Product Change Notification (PCN)

PCN #: 6A-2023

Jun 19, 2023

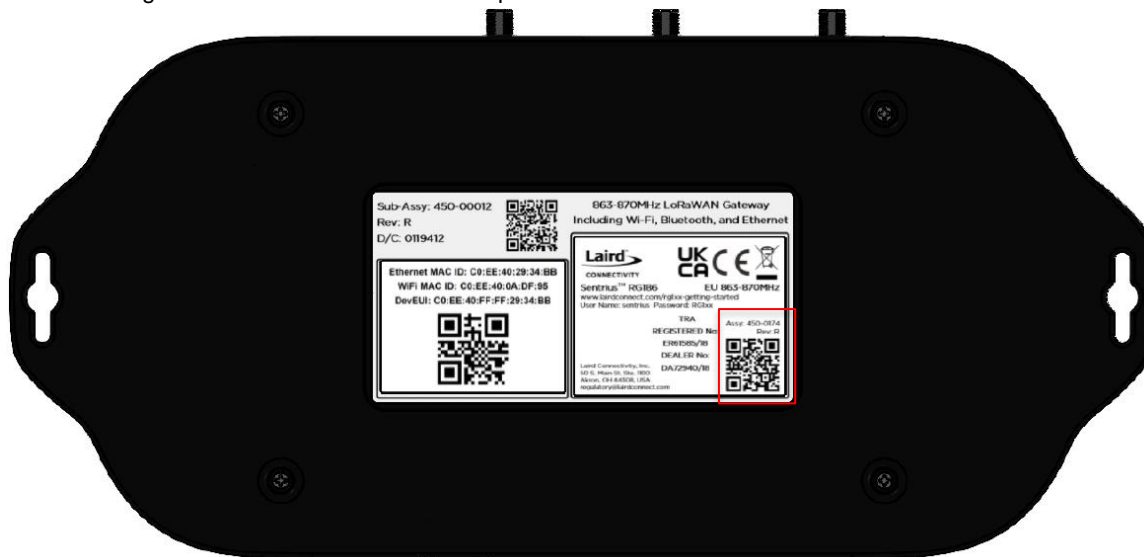
- Specific Part Number Changes: 450-00109-K2 previously 450-00109-K1
- Added Additional LTE Antenna Port
- Hardware changes to WB50 (453-00107) SiP (SSD50NBT) RF Shield and PCB Material

- GA 6.3 FW update for Sentrius Gateways
- Meet Carrier LTE Compliance for LTE IP67 Gateways
- Supplier Requirement on the WB50 Hardware Changes
